**April 25, 2017**

**ADDENDUM NO. 1**

**Durham County Courthouse Security System  
RFP 17-031**

# Courthouse 4th Floor

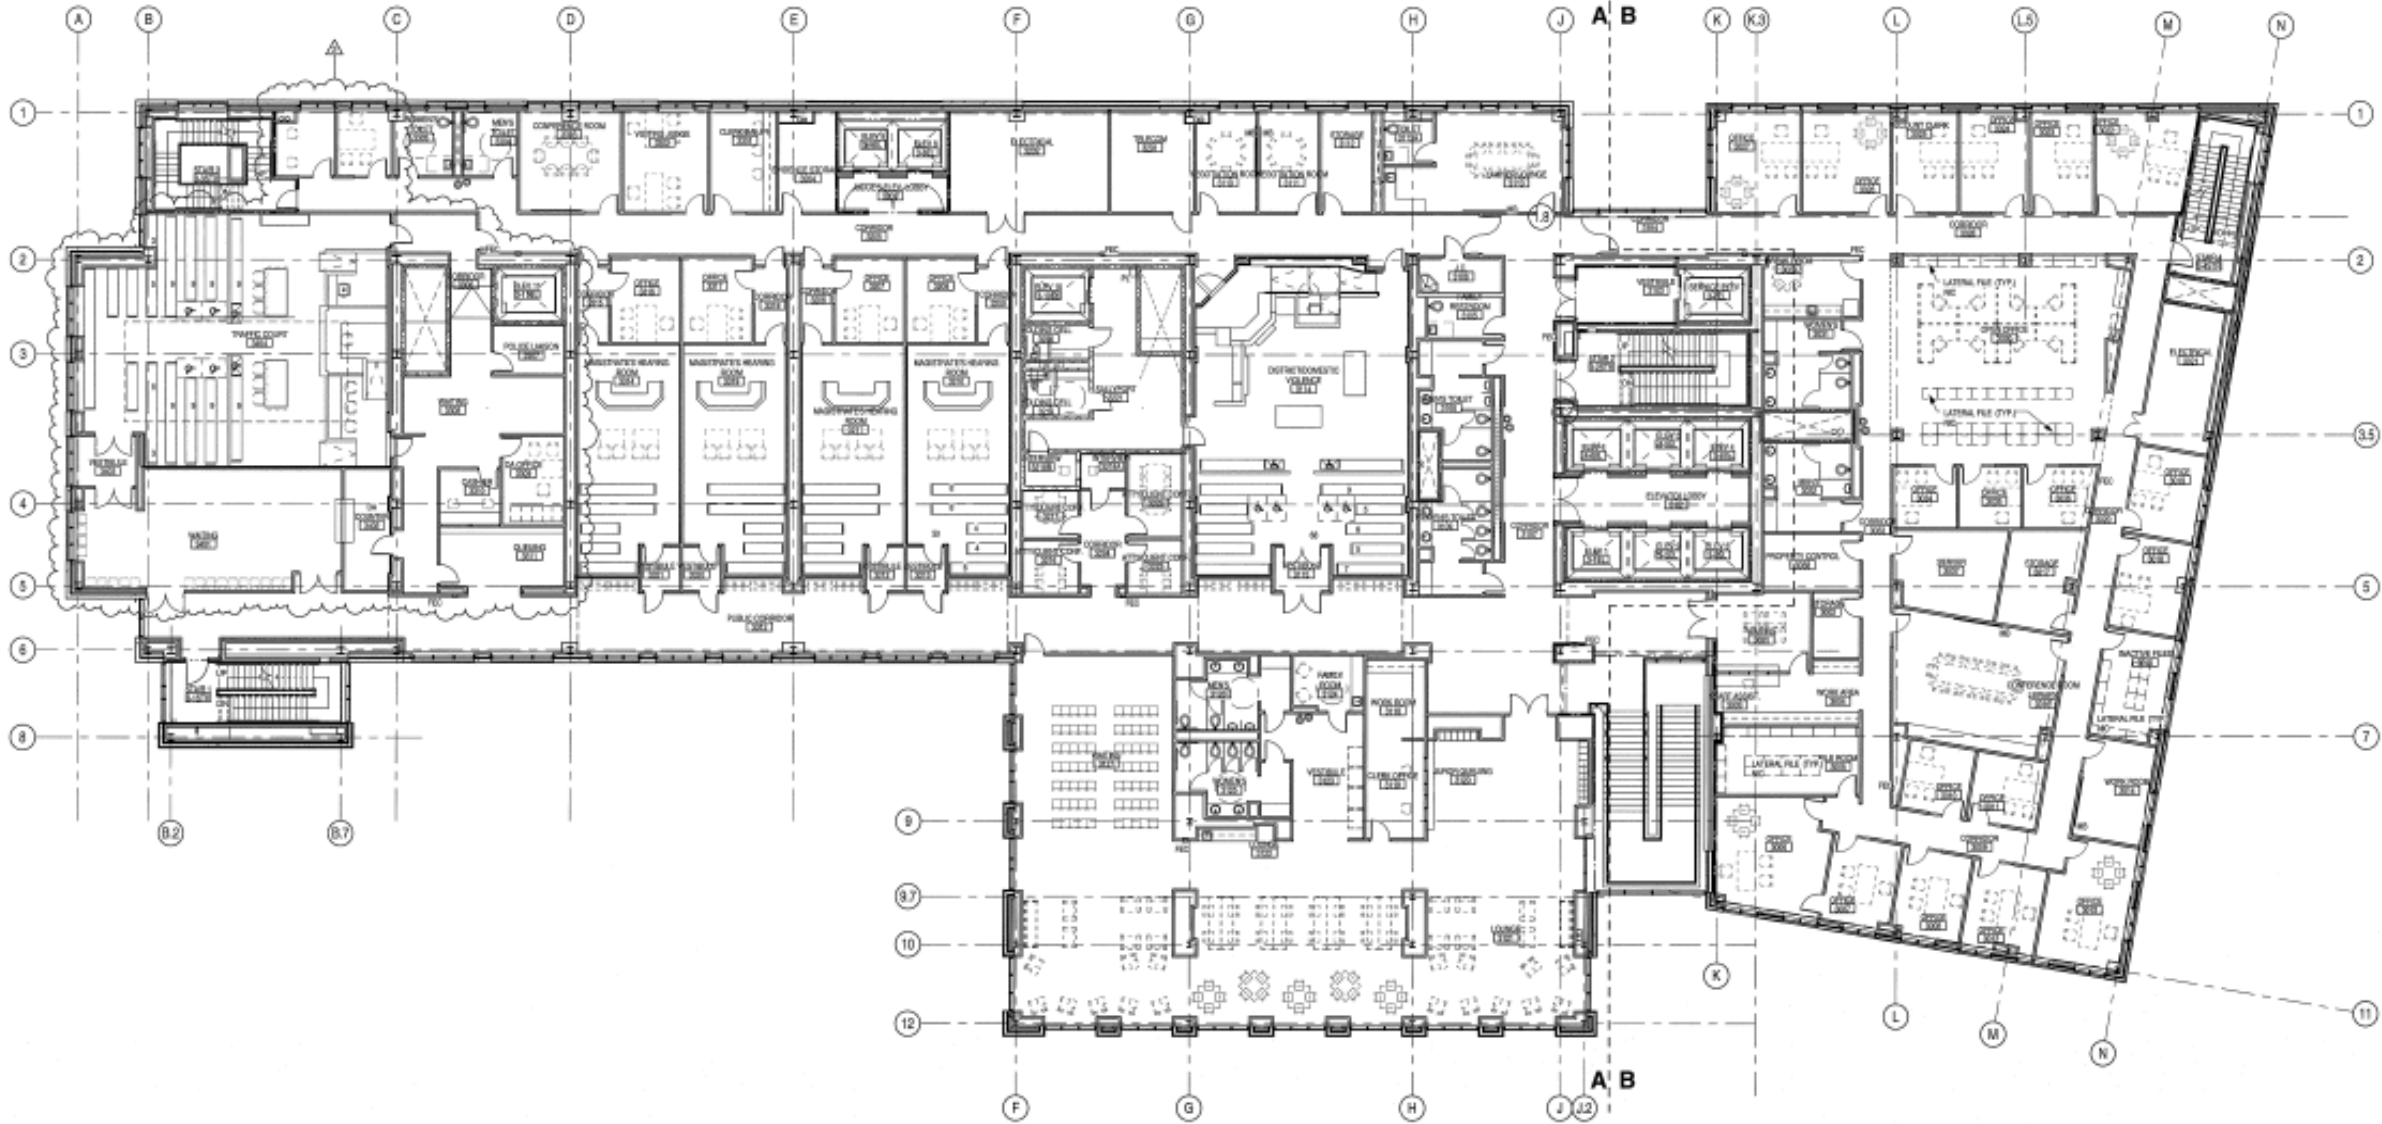
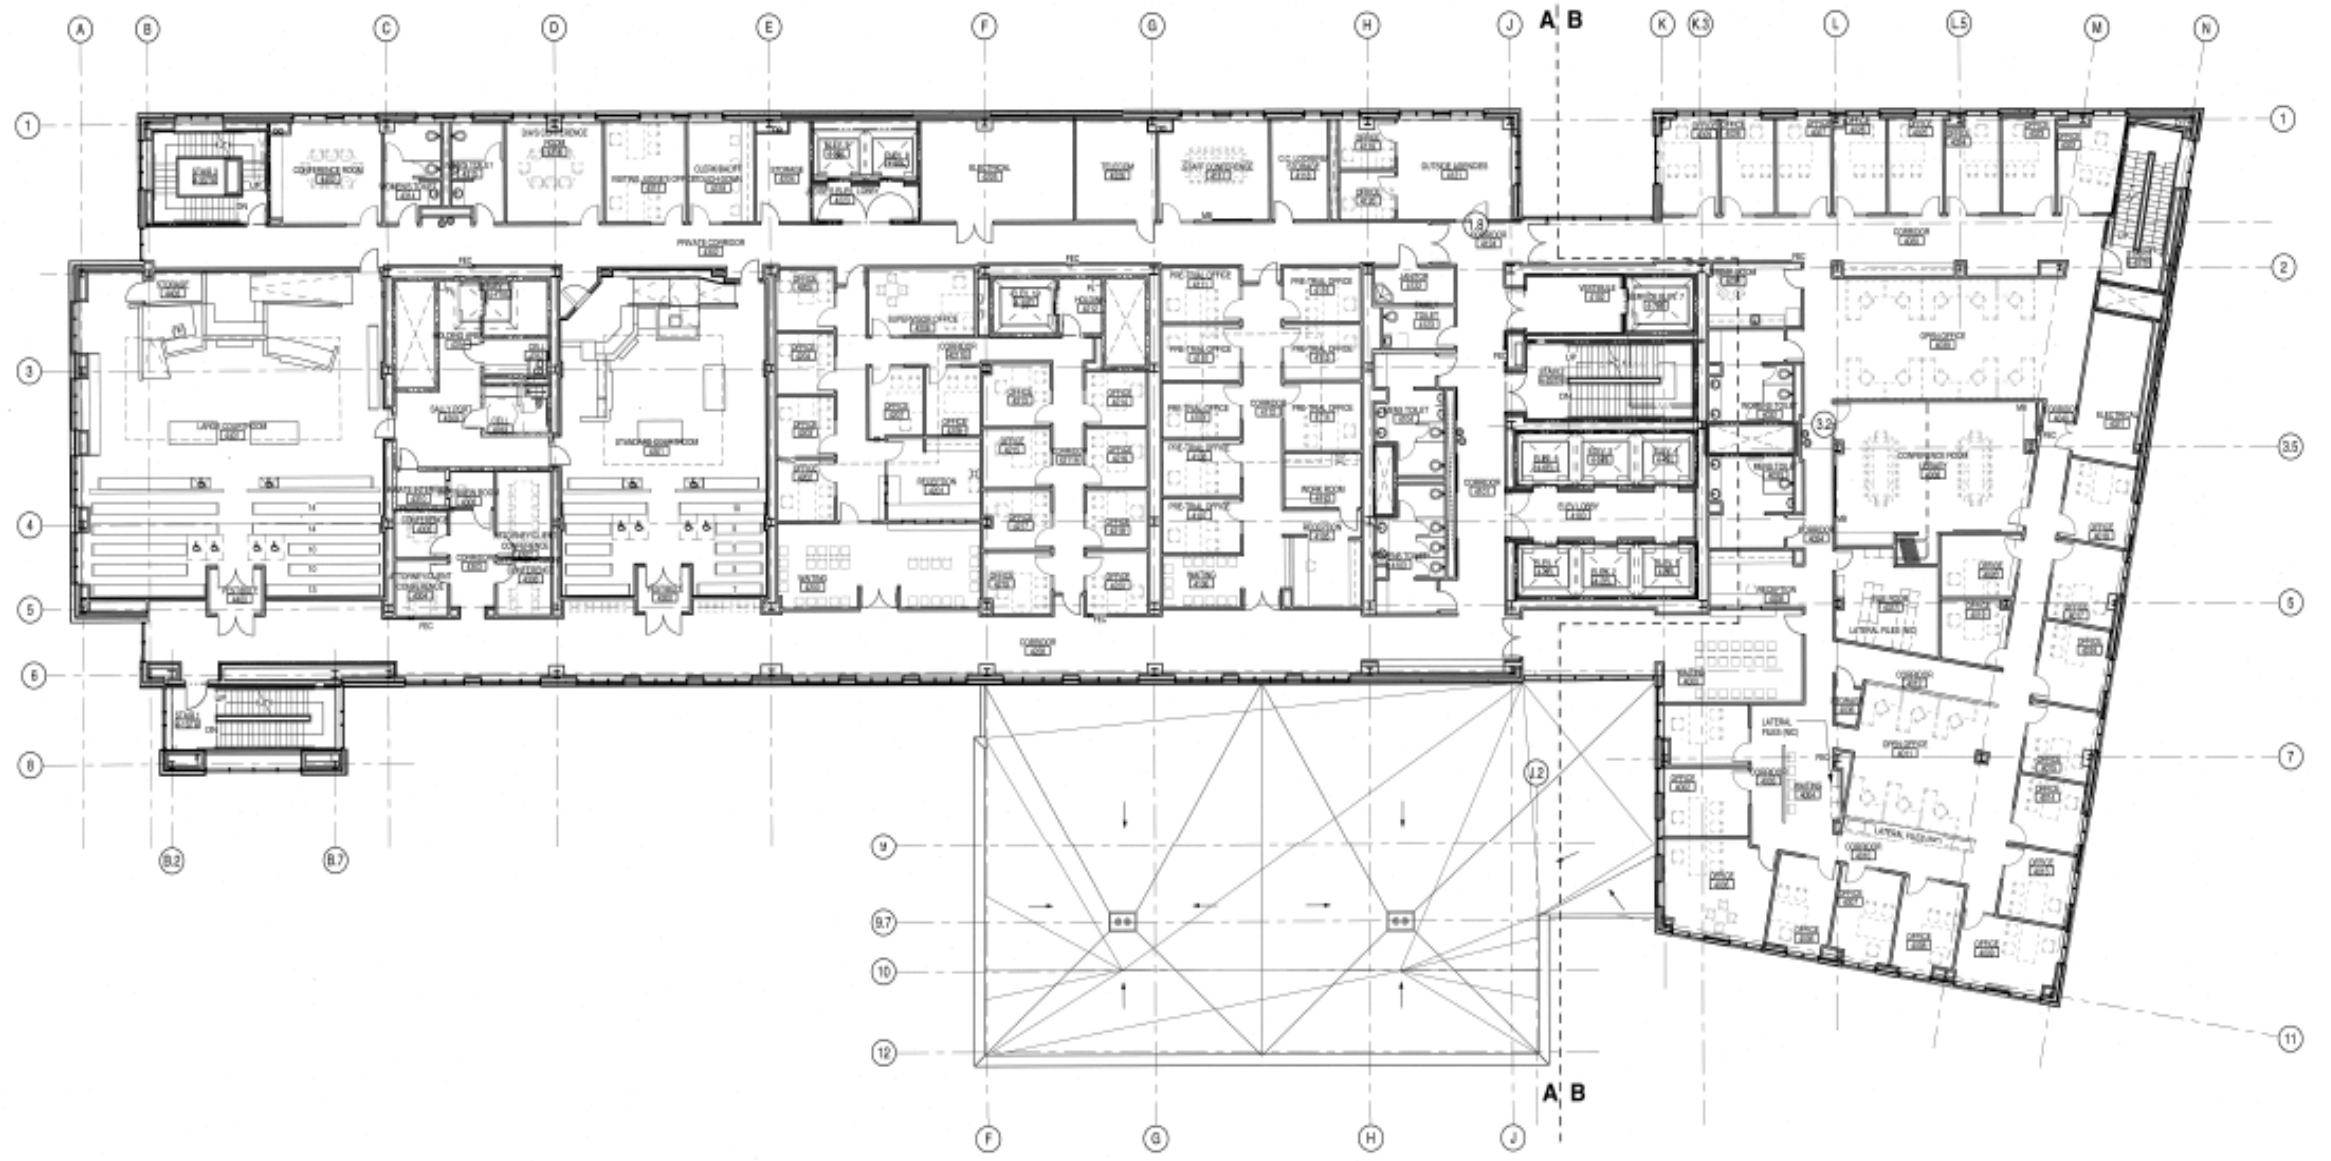
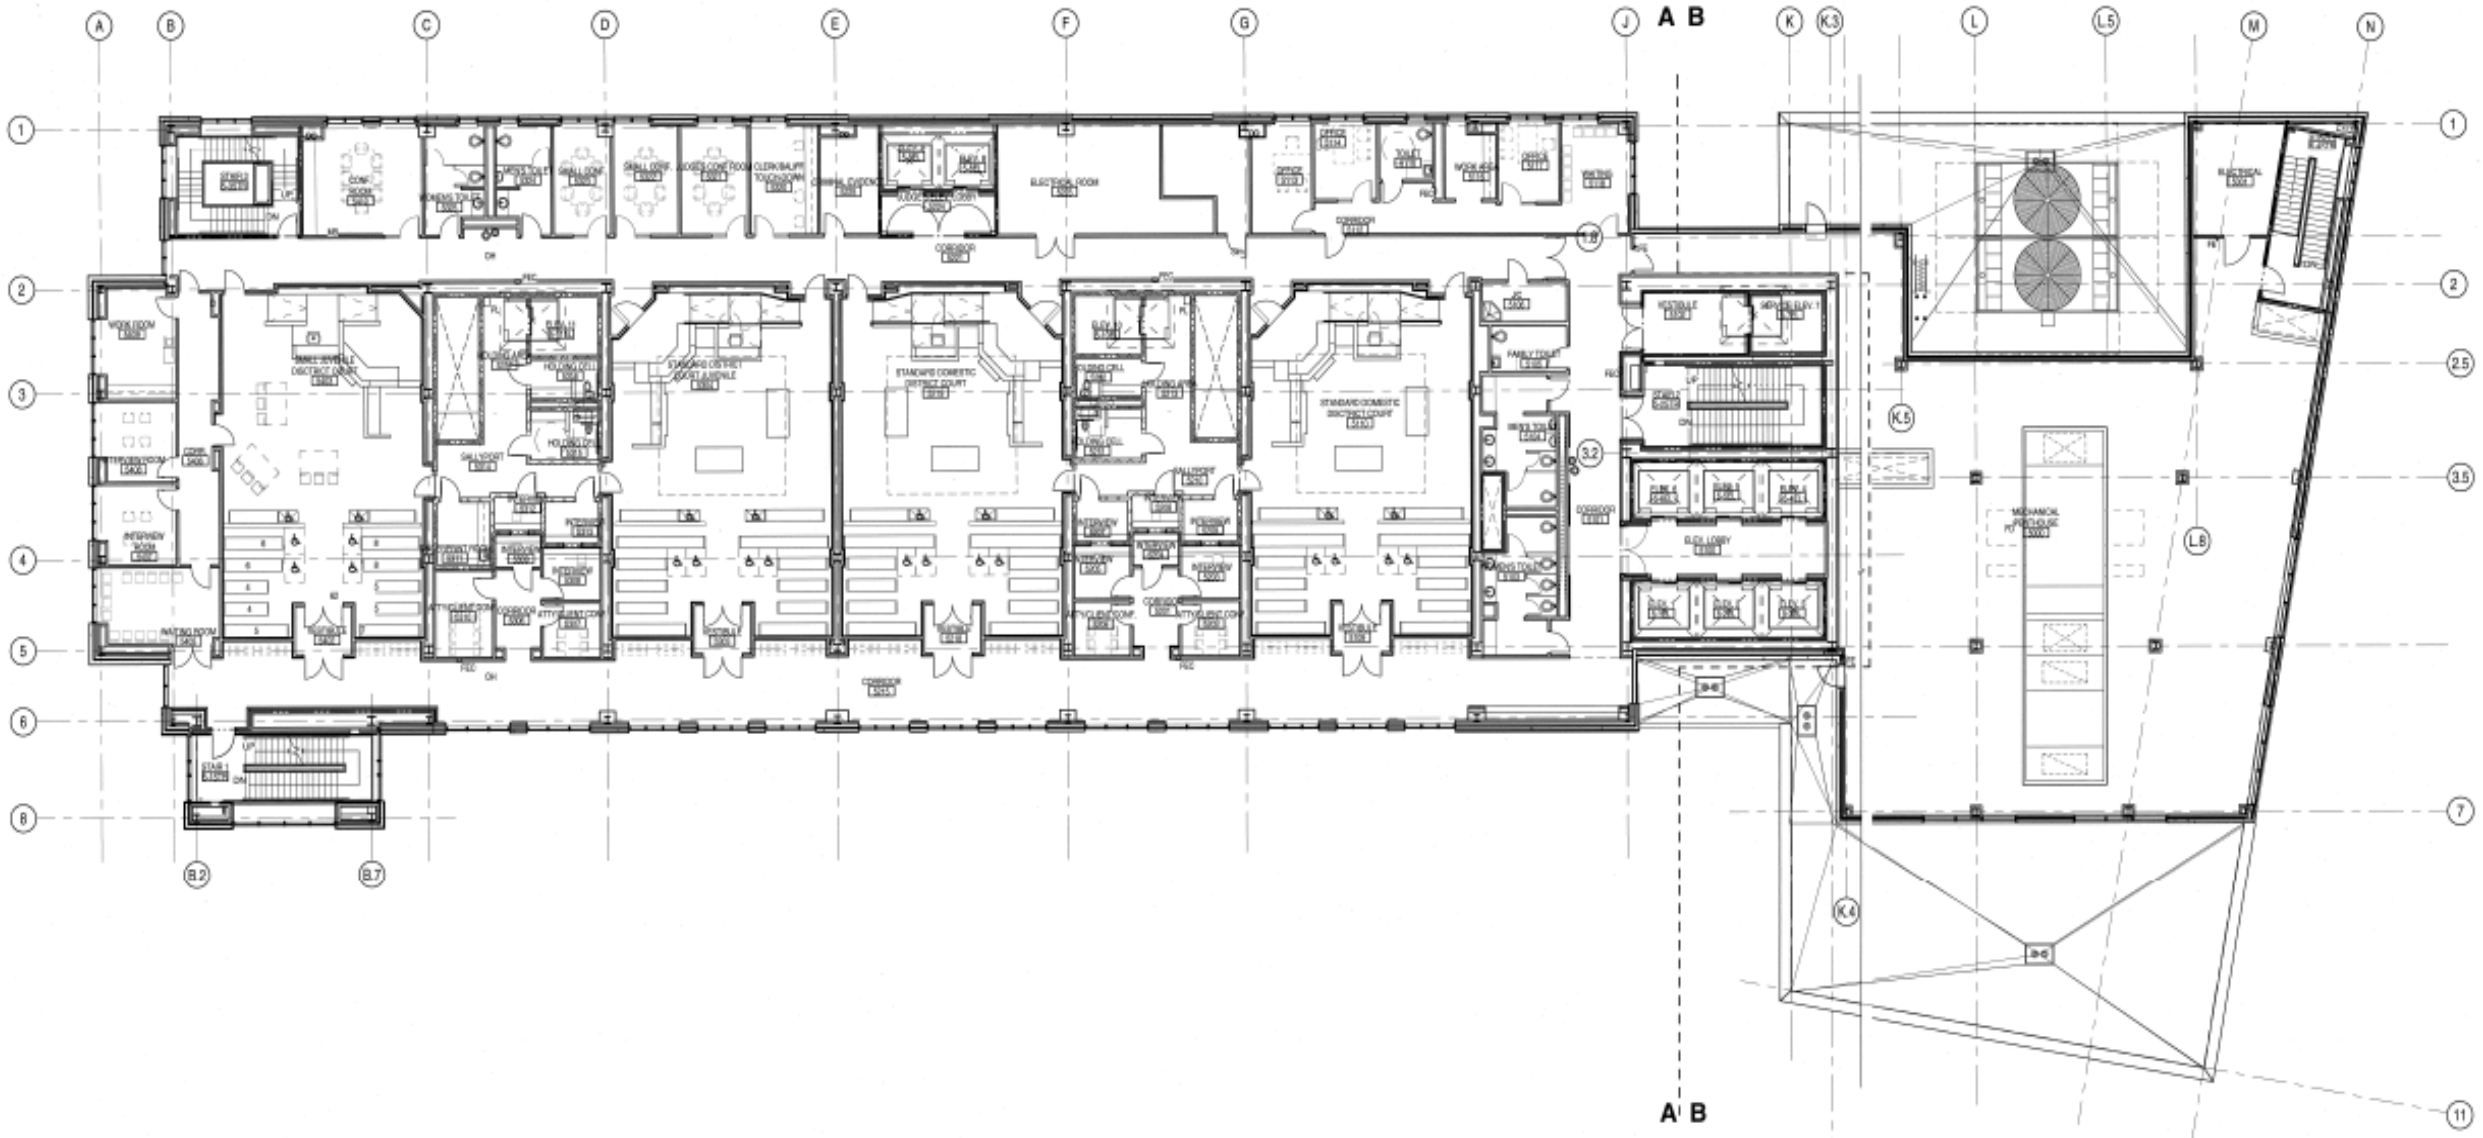
**Question 9** Are Maps required? If so, will CAD files be provided? Or will appropriate MAP files be provided?

**Question 27** Please provide a set of the PDF maps that are to be used in the system. This is to allow for estimating the amount of time to prepare the plans for importing into S2.

**Response** See Attachment 3 Durham County Courthouse Floor Plans

**Response** See Attachment 3, Durham County Courthouse Floor Plans
